RENESAS TECHNICAL UPDATE

| Product Category | MPU & MCU | | Document No. | TN-RX*-A111A/E | Rev. | 1.00 |
| Title | Corrections to User's Manual regarding the FASR.EXS bit for the Flash Memory in the RX111 Group | | Information Category | Technical Notification | | |

This document describes corrections to the description for the FASR.EXS bit in section 35. Flash Memory of RX111 Group User's Manual: Hardware Rev.1.10.

Figure 35.10 Procedure to Issue the Program Command for the ROM

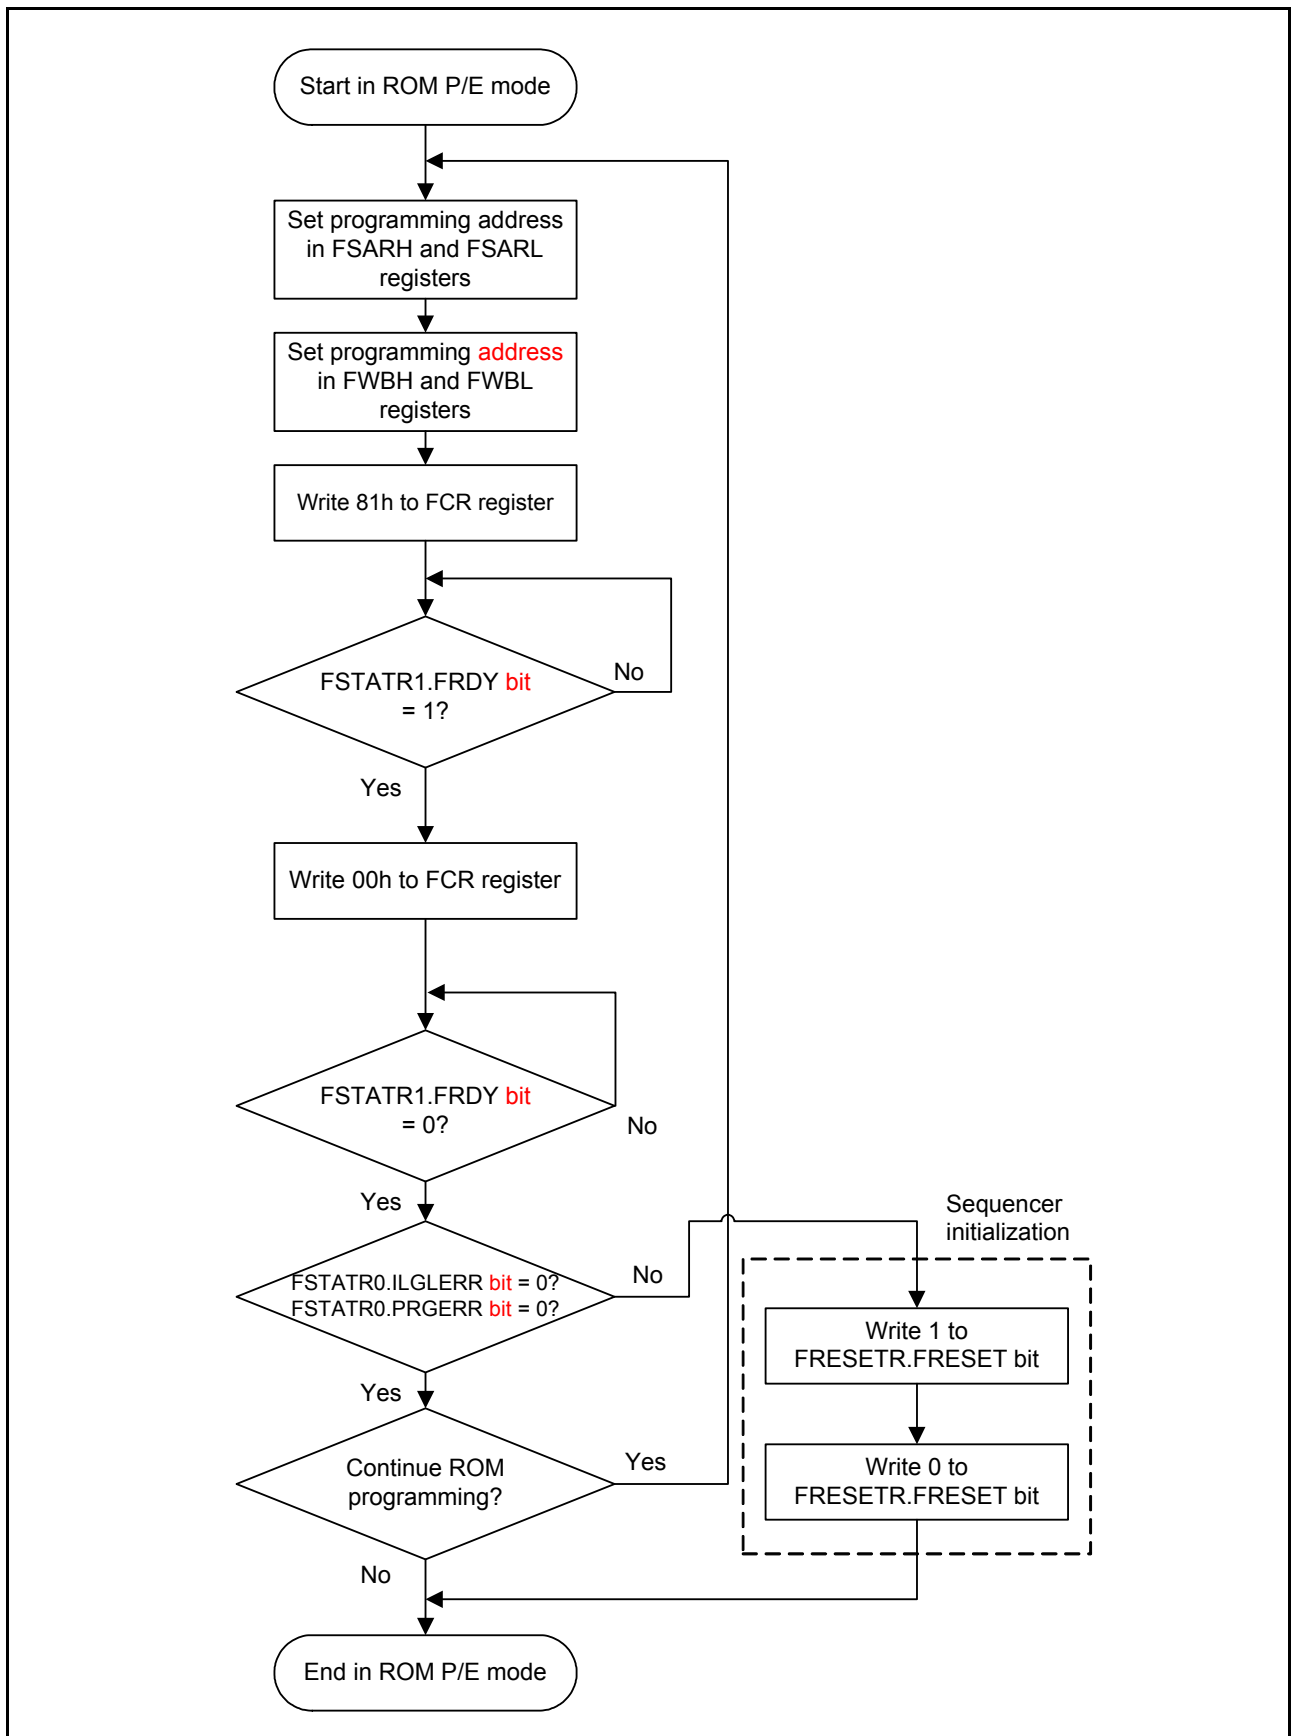
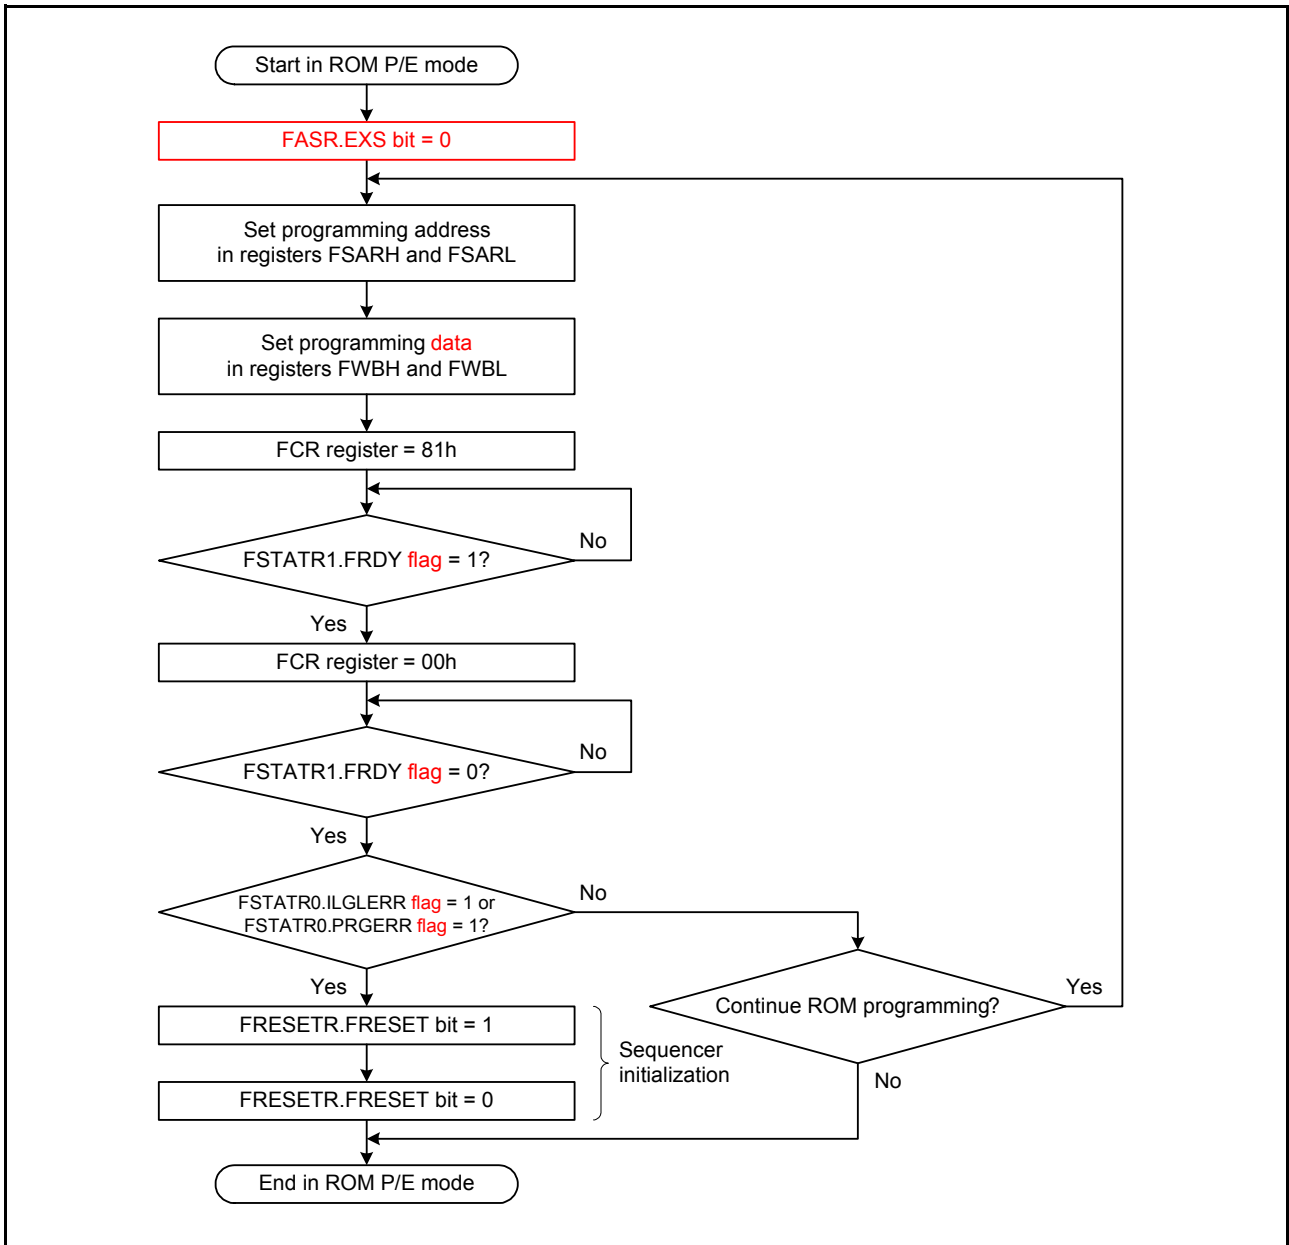
Figure 35.10 in (3) Programming and Erasure Procedures of 35.7.3 Software Command Usage is corrected as follows:

Figure 35.11 Procedure to Issue the Program Command for the E2 DataFlash

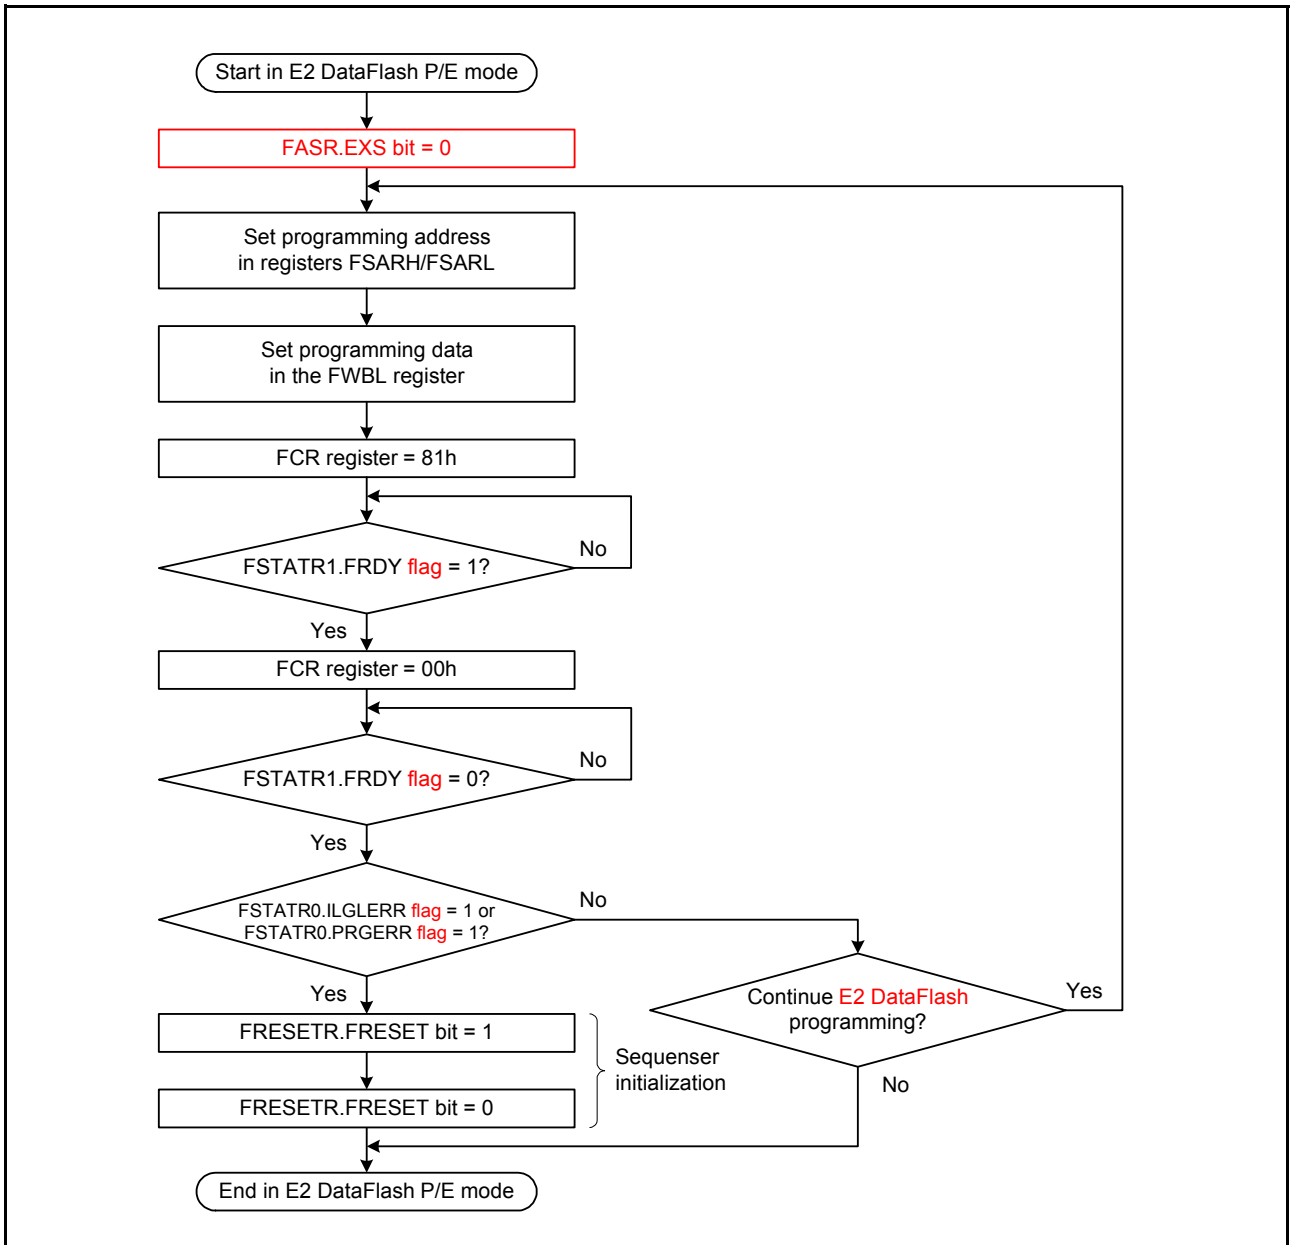
Figure 35.11 in (3) Programming and Erasure Procedures of 35.7.3 Software Command Usage is corrected as follows:

Figure 35.12 Procedure to Issue the Block Erase Command for the ROM

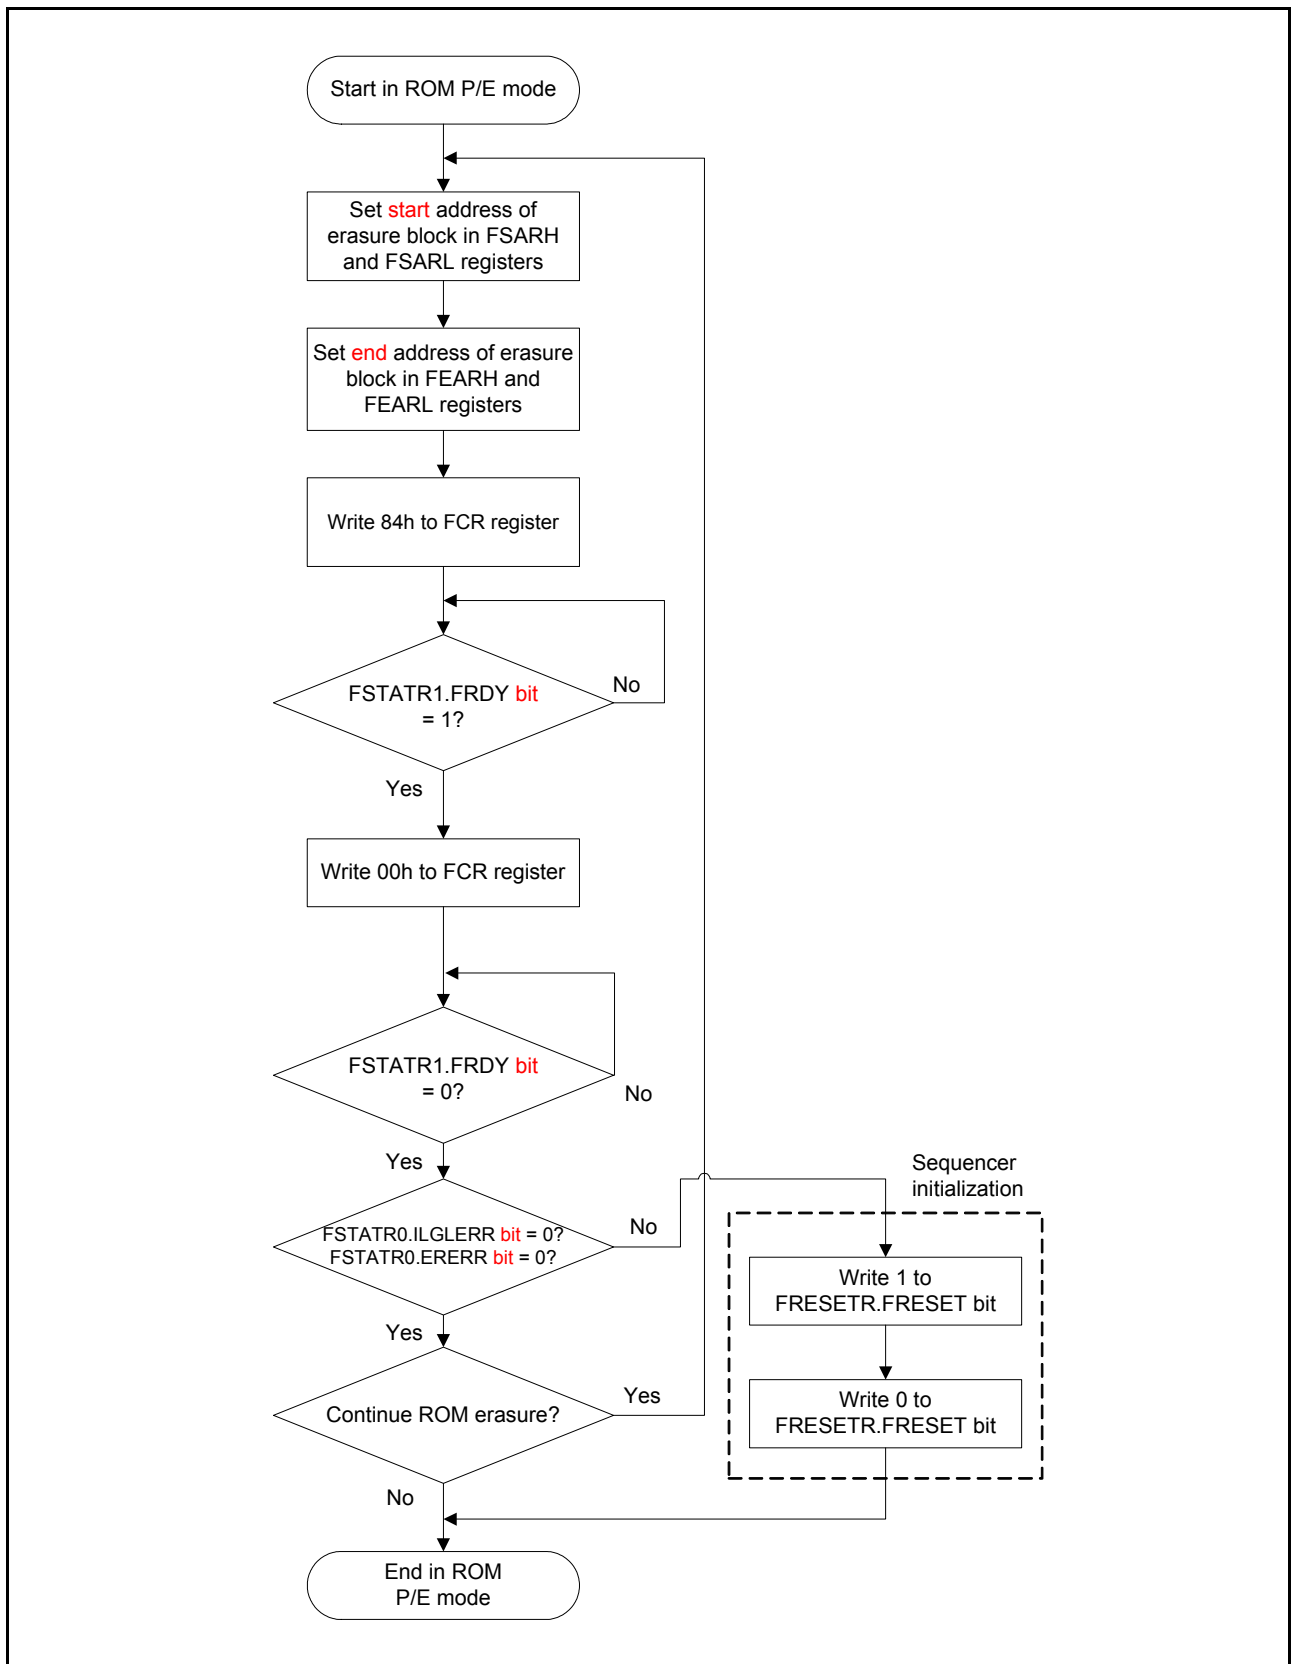
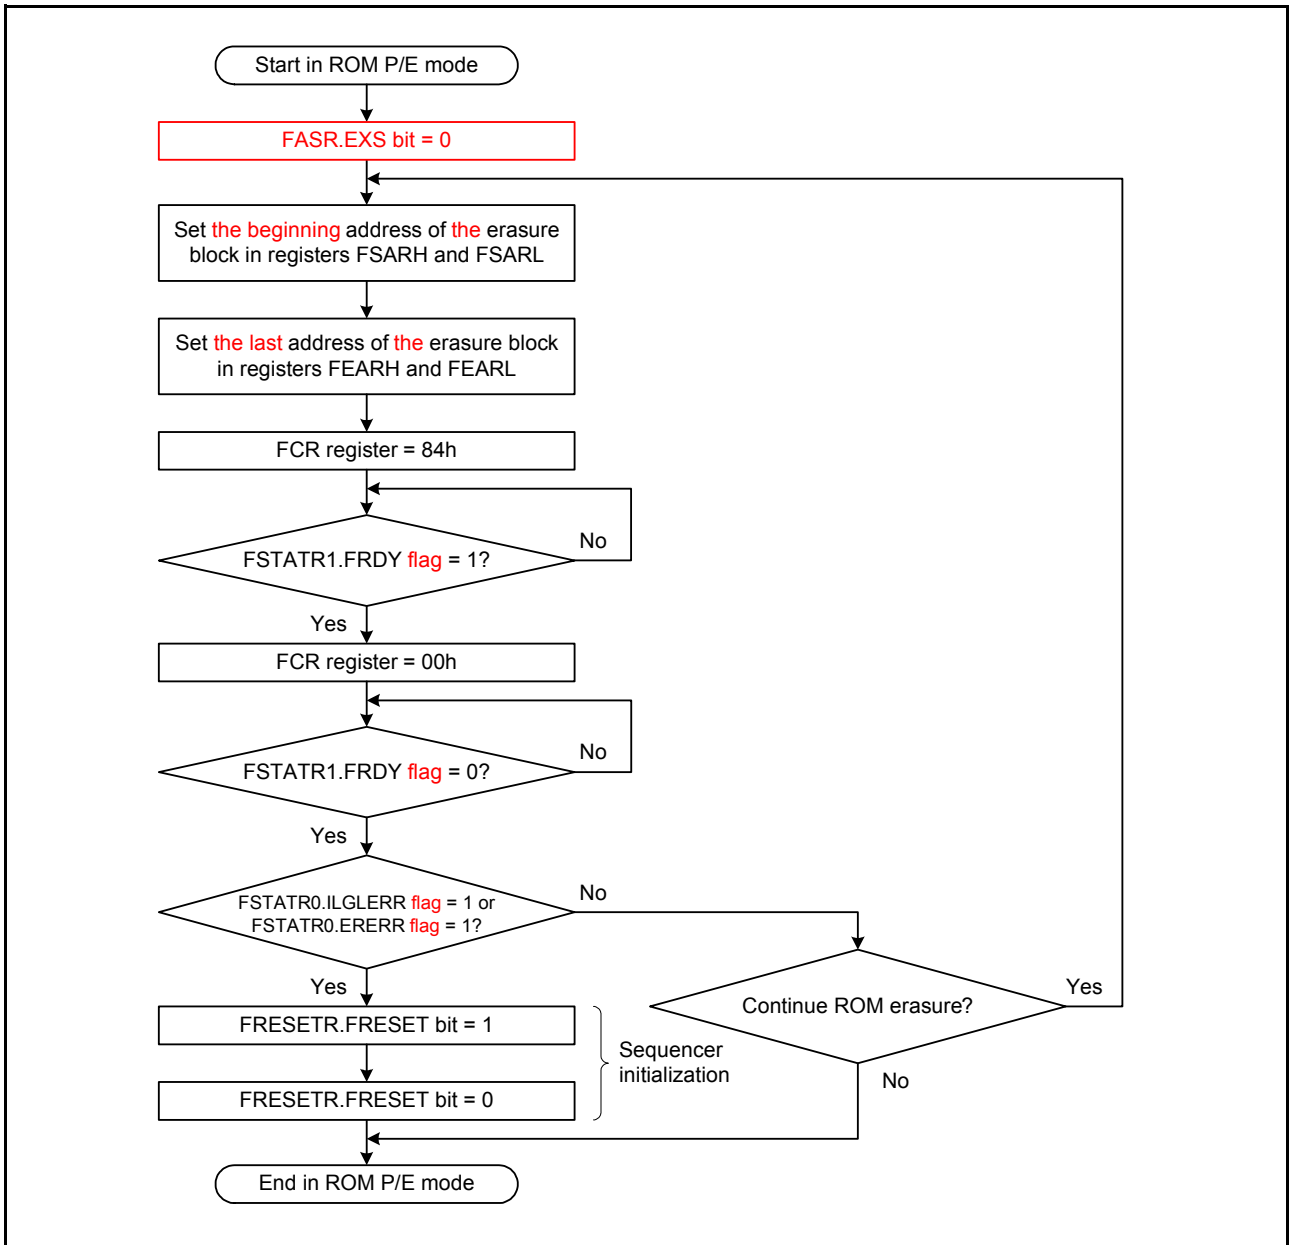
Figure 35.12 in (3) Programming and Erasure Procedures of 35.7.3 Software Command Usage is corrected as follows:
